# TEXAS TURNPIKE AUTHORITY

## CONTRACT No. DNT-260

# MECHANICAL, ELECTRICAL AND PLUMBING PLANS

# ADDISON AIRPORT TUNNEL

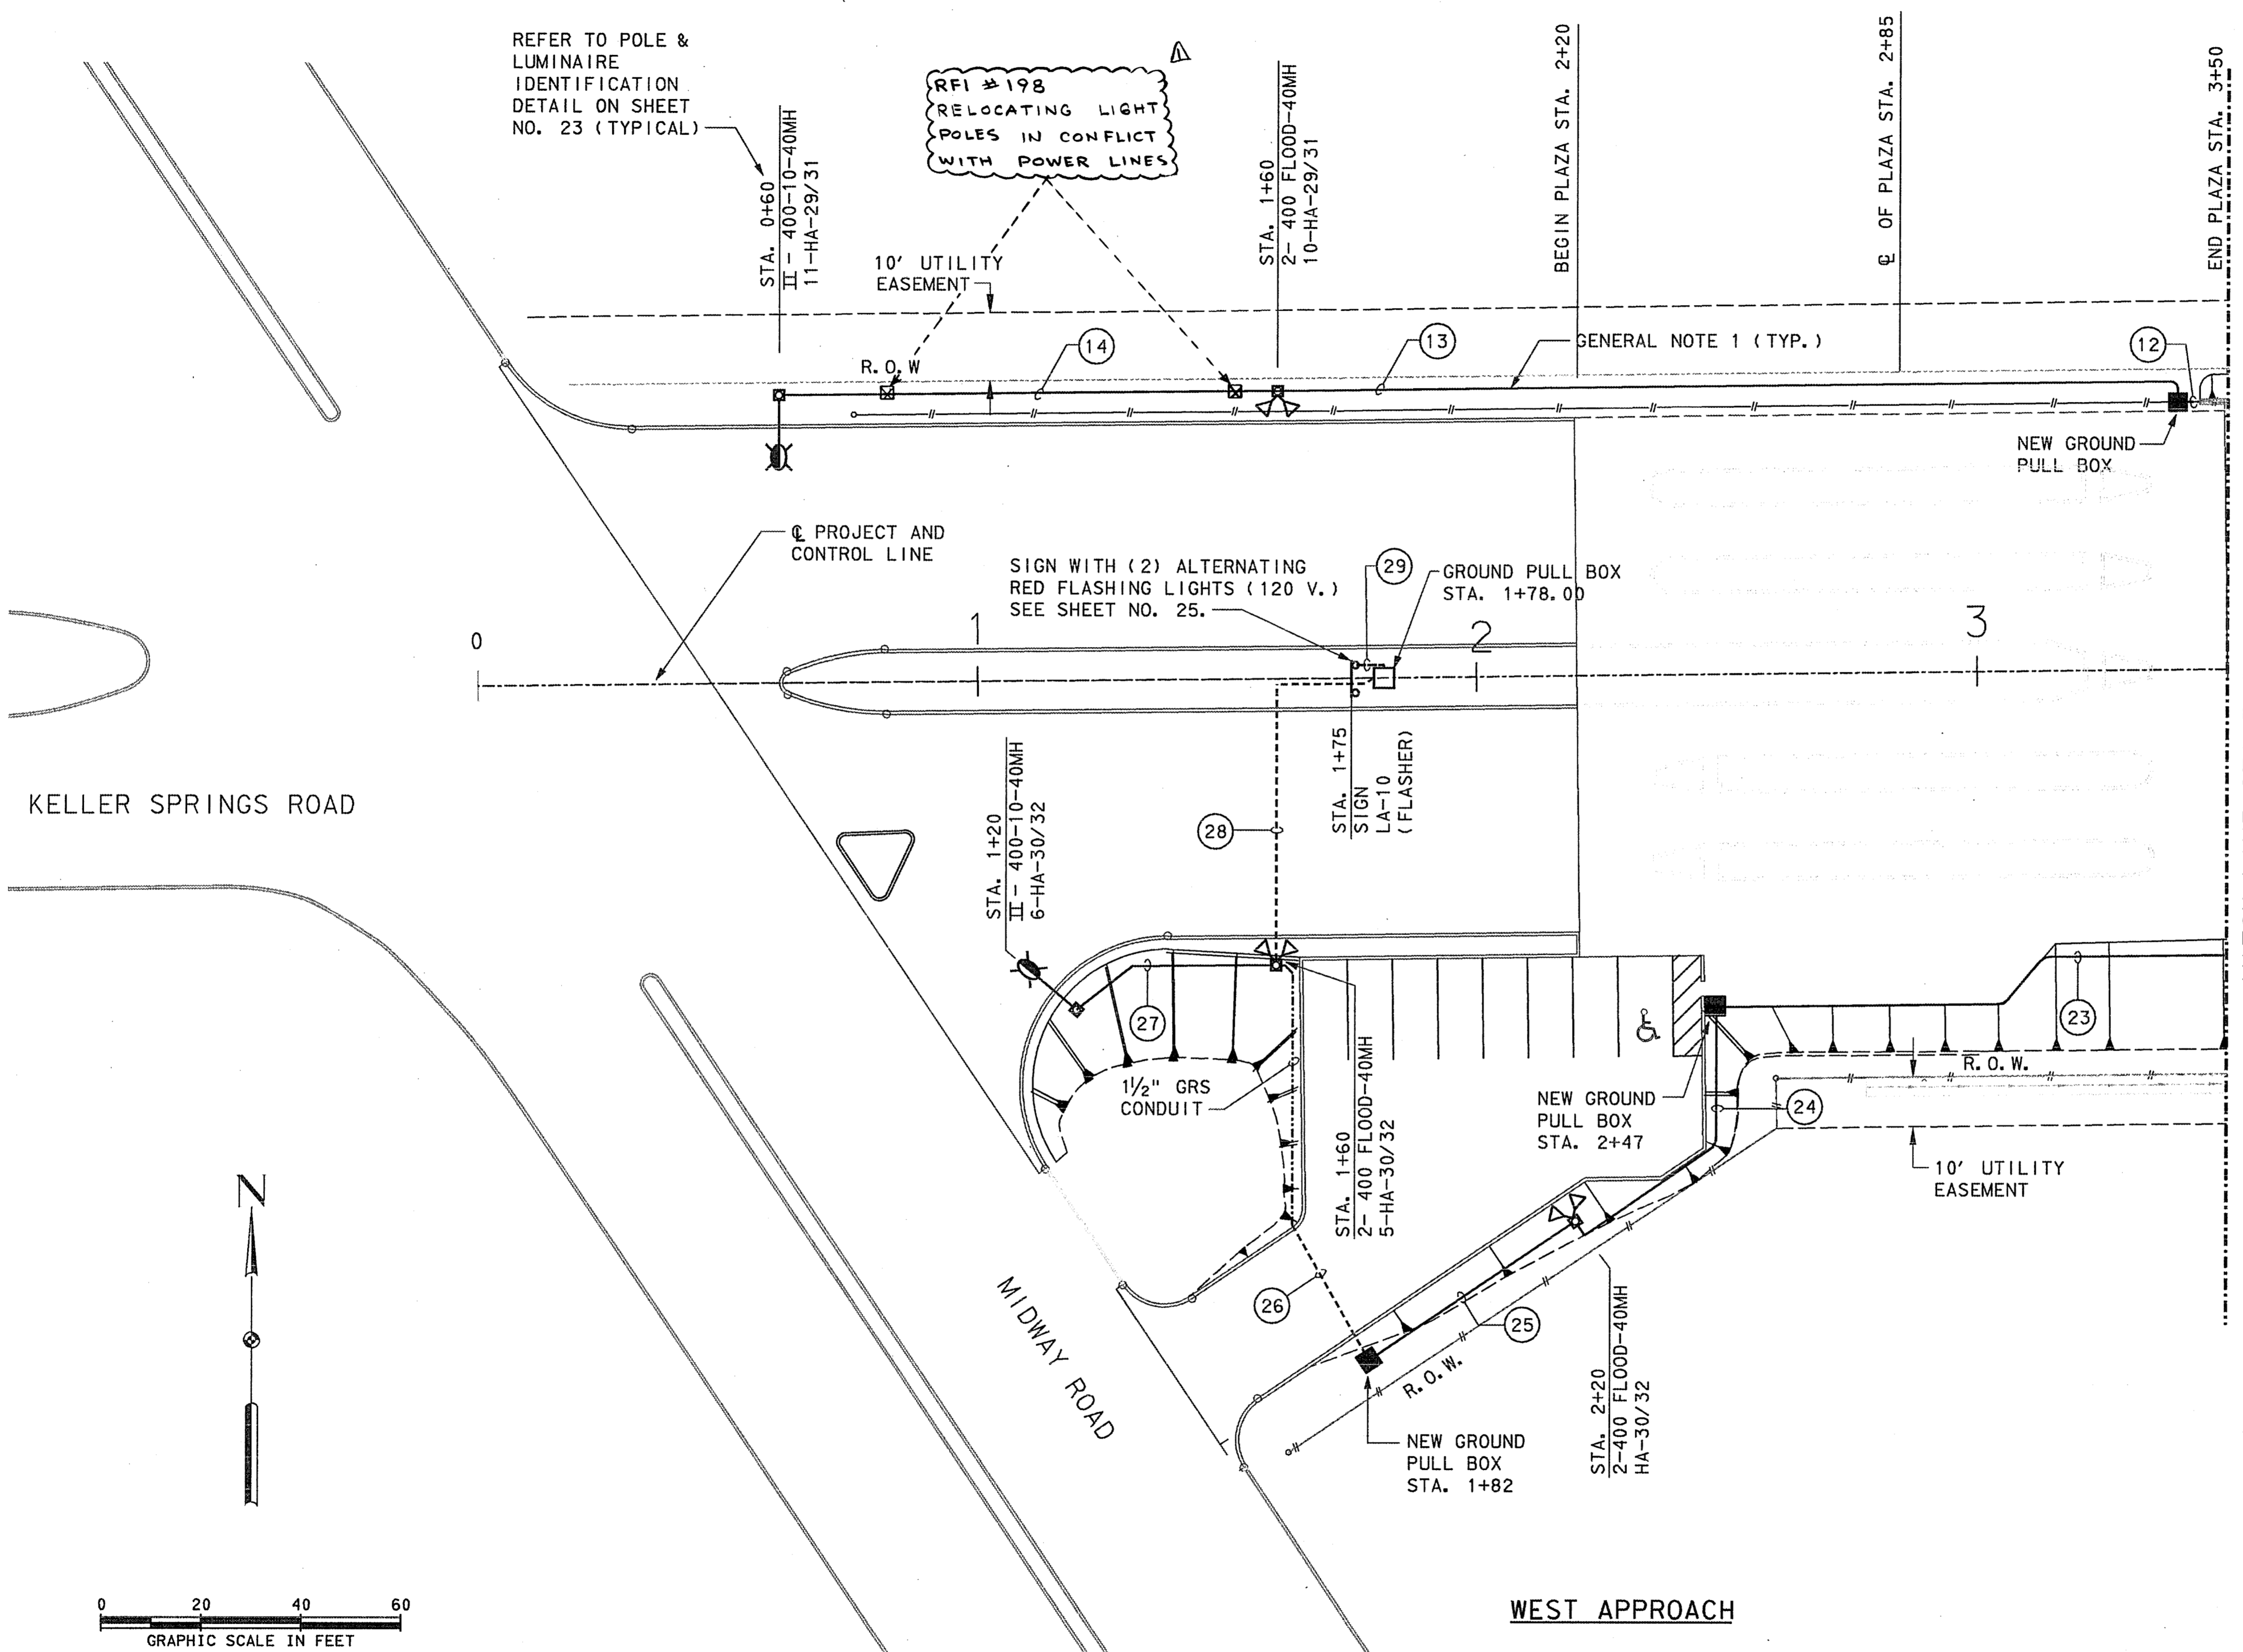
REVISED PER RFI #198			
No.	REVISION	BY	DATE
NORTH TEXAS TOLLWAY AUTHORITY ADDISON AIRPORT TUNNEL			
ROADWAY ILLUMINATION LAYOUT STA. 0+00 TO STA. 3+50			
MATED CONSULTING ENGINEERS, INC. 5500 PETERSON LANE SUITE 225 DALLAS, TEXAS 75240 (972) 233-8700			SECTION XIII
DRAWN: SAA	DATE: 5/97	DESIGNED: DR	DATE: 5/97
CHECKED: RJM	DATE: 5/97	SCALE: 1"=20'	
CONTRACT No. DNT-260 SHEET 18 OF 52

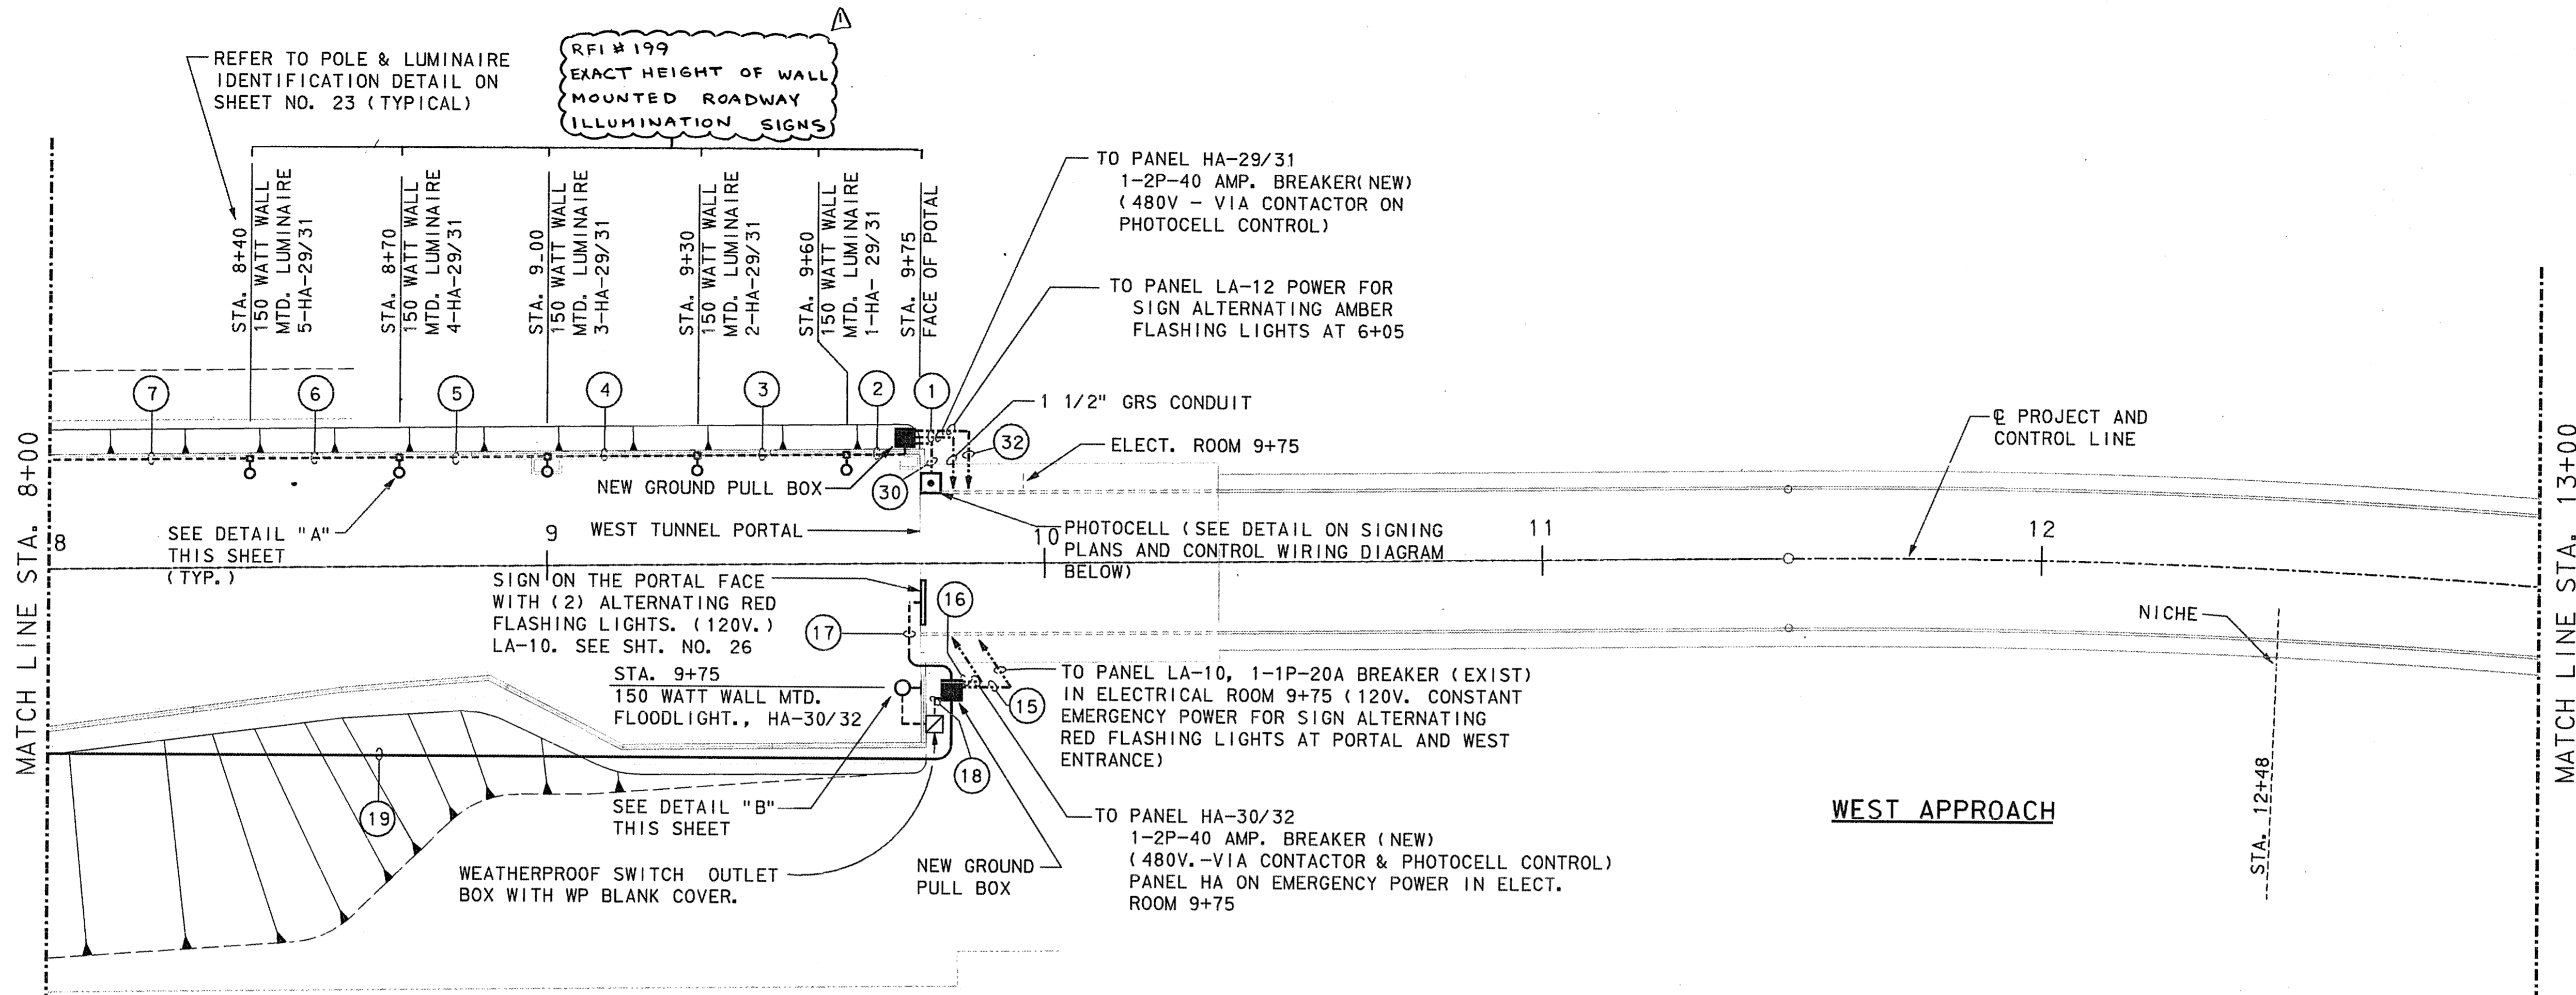
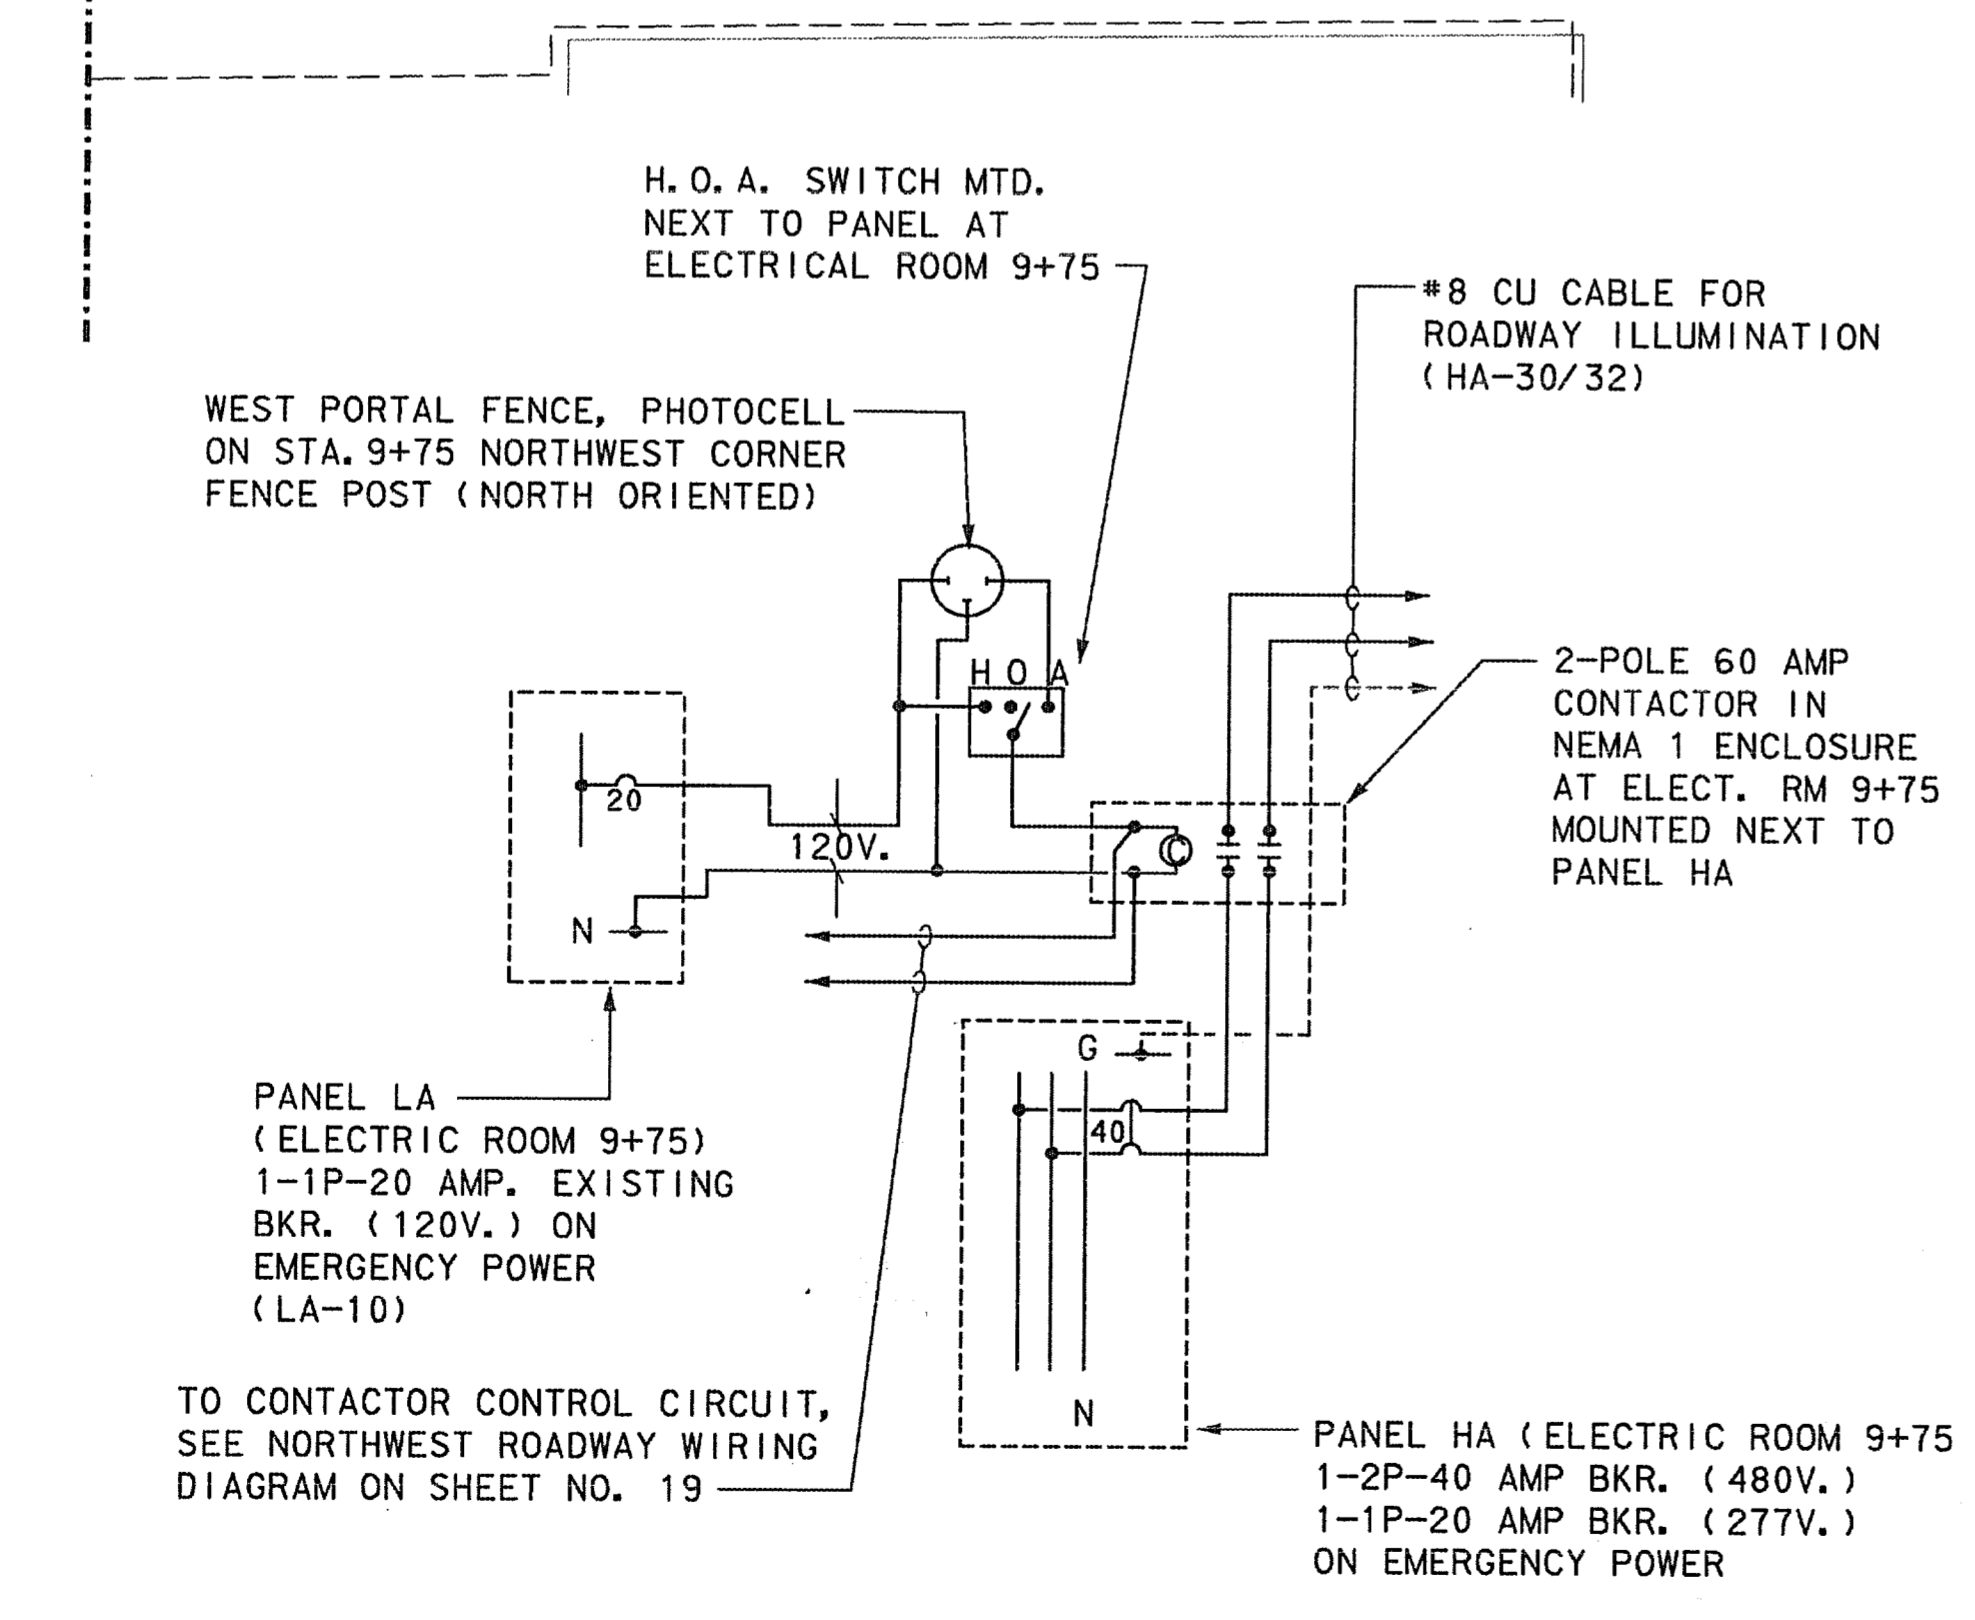
REVISION PER RFI # 199			
No.	REVISION	BY	DATE
NORTH TEXAS TOLLWAY AUTHORITY ADDISON AIRPORT TUNNEL			
ROADWAY ILLUMINATION LAYOUT STA. 8+00 TO STA. 13+00			
MCE MATED CONSULTING ENGINEERS, INC. 3500 PETERSON LANE SUITE 225 DALLAS, TEXAS 75240 (972) 233-6700		SECTION XIII	
DRAWN: SAA	DATE: 5/97	DESIGNED: DR	DATE: 5/97
CHECKED: RJM	DATE: 5/97	SCALE: 1"=20'	
CONTRACT No. DNT-260 SHEET 20 OF 52
